Subject: RE: PL-2023-07503 comments

Section 2.9 of the Drainage Technical Note 0654 rev F dated 09/08/2023 still refers to 3no. infiltration basins, and the Notes section of the Drainage Layout PDL-101 rev H has a numbering error. We have had to assume that these are only typographical errors, and that there are no substantive errors in the submitted documents.

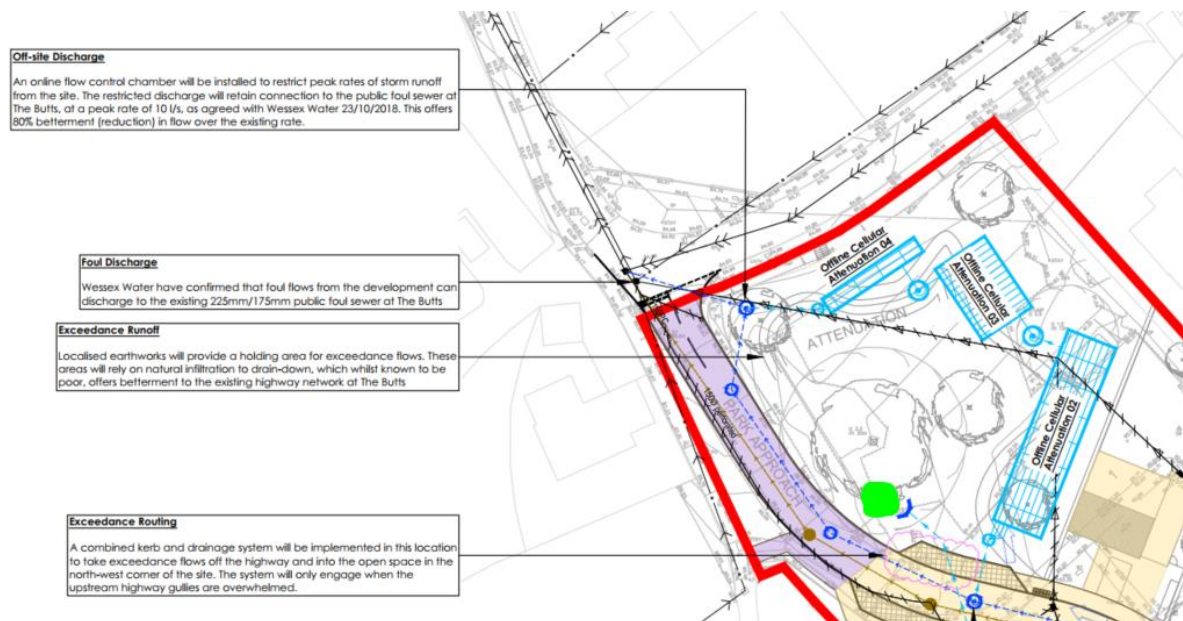
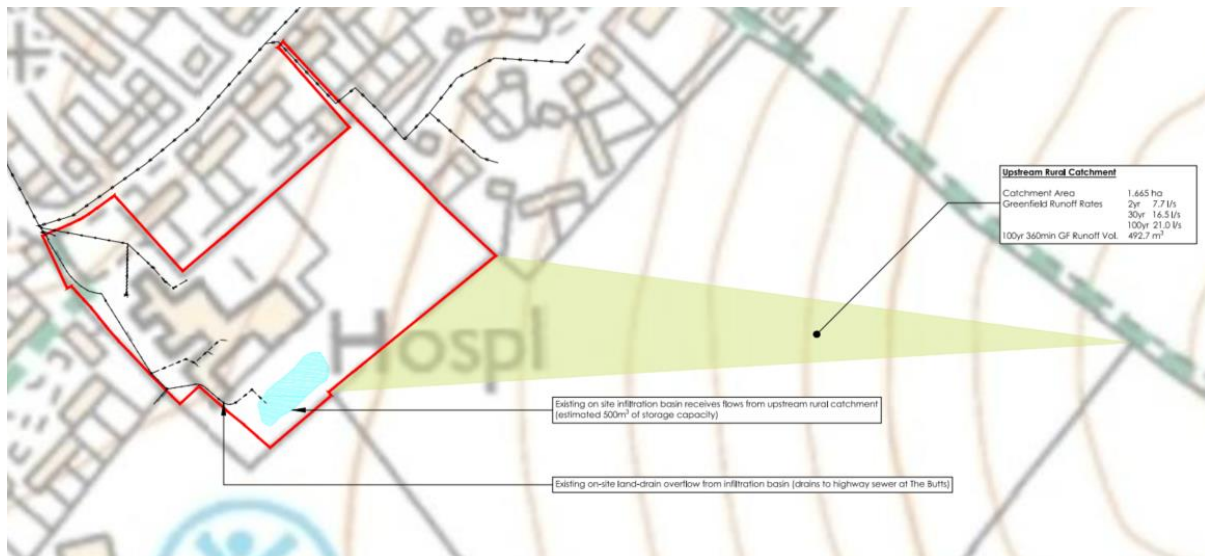
The photos seem to show a depression full of water that relate to what the plan calls Localised earthworks for exceedance flows. The arrow is pointing to the wrong place and should be pointing to the green blob (first image below). The outfall next to the green blob is the outfall from a private SW system that transfers flows from an infiltration basin and land drainage that was already there. This discharged directly into the SW drain in The Butts (Image 2)

Clearly if this pond is filling and the larger ponds upstream are empty it would suggest some sort of misconnection but I don't see how they can just get away with discharging the land drain to a shallow pond

Something is not working and to have a pond overflowing onto the highway and down the drains is not acceptable
